PROPOSED MINOR AMENDMENTS

NOTE: THESE PROPOSED MINOR AMENDMENTS RELATE TO AN ORIGINAL DESIGN BY CHRIS DYSON ARCHITECTS [PLANNING APPROVAL REF: 2019/5443/P] WITH MINOR AMENDMENTS BY MDA & MILK STUDIO [PLANNING APPROVAL REF: 2020/3584/P] AND RELATED LISTED BUILDING APPROVALS 2019/5469/L AND 2020/3585/L

12 Keats Grove,
Hampstead,
London, NW3 2RN

1 Proposed Upper-Ground Floor
Scale: 1:50

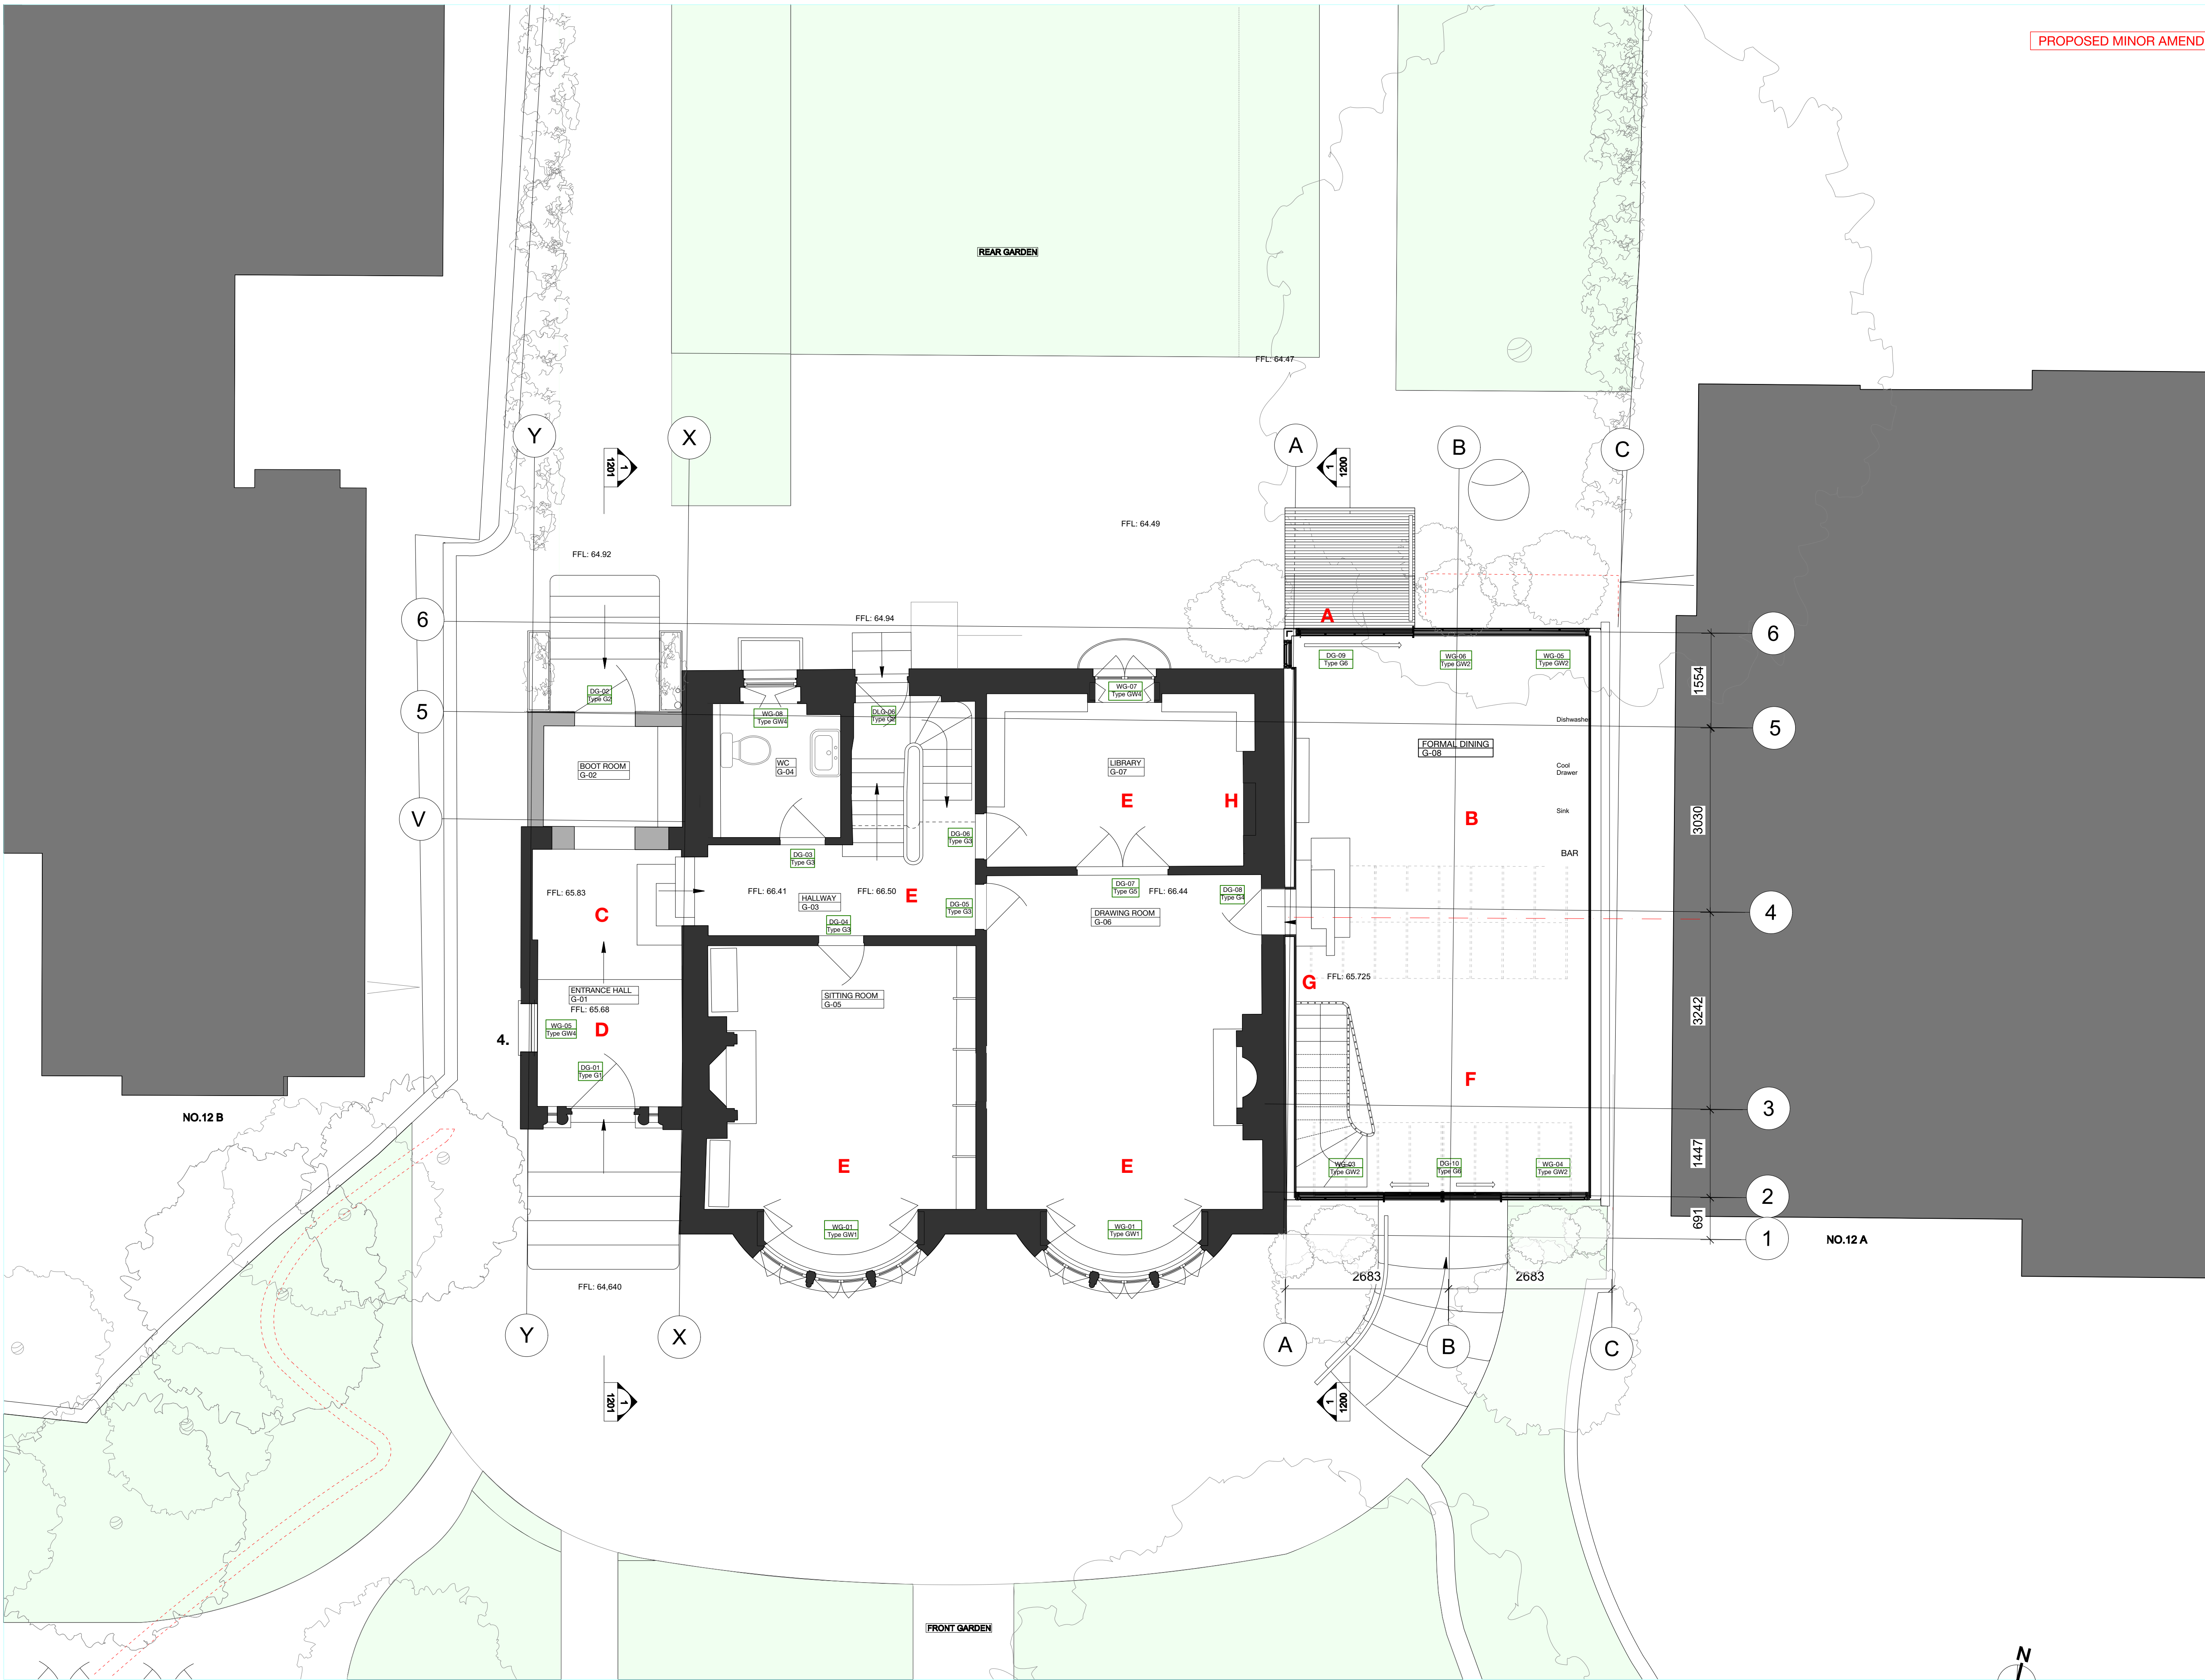
- UGF Proposed Minor Amendments by 51 architecture:**
- A:** Vary position of sliding doors to enable usable steps to garden due to tree being incorrectly located on previously approved plans
 - B:** Use east extension as a formal dining room with a bar and retain a family kitchen on the Lower Ground Floor
 - C:** Omit proposed roof lights, retain existing window
 - D:** Use British Swaledale honed limestone for flooring in entrance hall
 - E:** Replace existing non original narrow modern boards with historically sympathetic aged oak wide board flooring
 - F:** Use end grain oak floor boards in east extension
 - G:** Use the same natural breathable plaster finish approved for the historic house on interior walls in the east extension
 - H:** Omit reopening and reinstating fireplace in Library LG-05 shown on approved drawings. Retain as existing.

Proposed Lower Ground

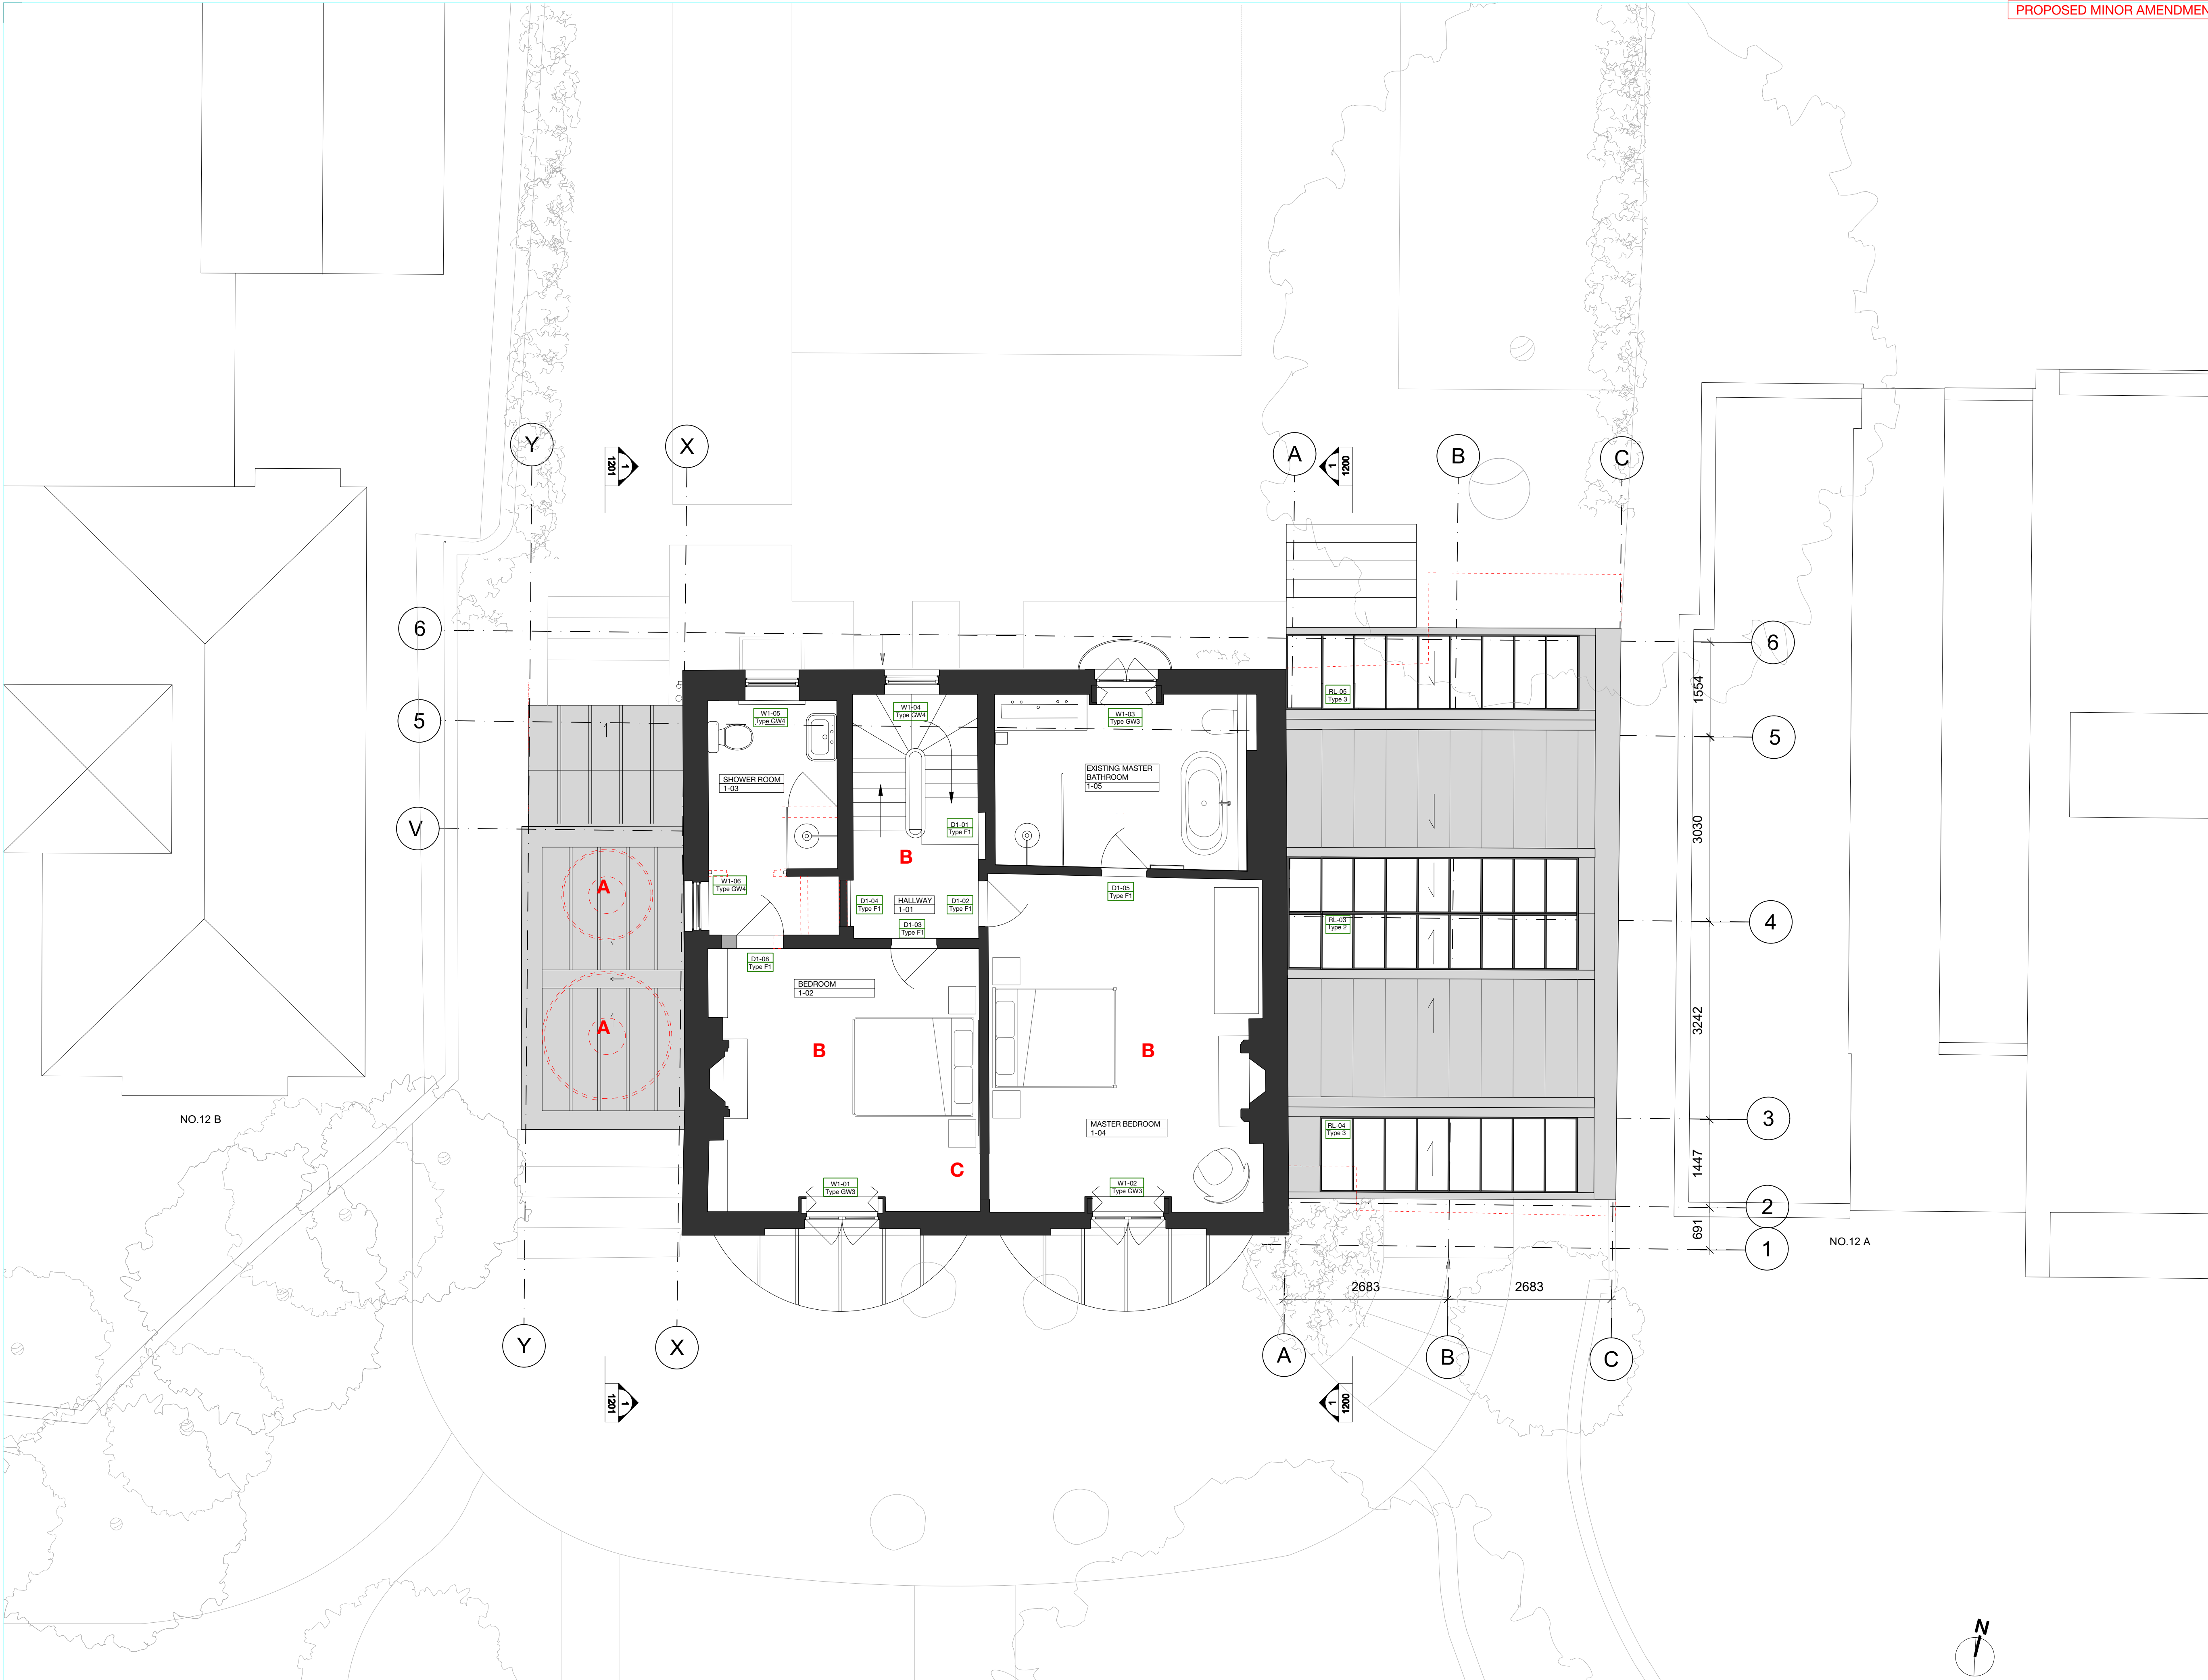
- LGF Proposed Minor Amendments by 51 architecture:**
- A:** Retain use of Lower Ground Floor for family kitchen dining, keeping the current kitchen location. Retain the open plan arrangement of LG-04 and LG-06 for living and informal dining.
 - B:** Renovated guest bathroom opposite family room
 - C:** Enclose laundry in new east extension
 - D:** Add electrical room to new east extension
 - E:** Addition of a bathroom to service the formal dining room space
 - F:** Replace modern terrazzo floor finish with stone flags throughout
 - G:** Omit reopening and reinstating fireplace 4 in Kitchen LG-04 and LG-05 shown on approved drawings. Retain as existing.
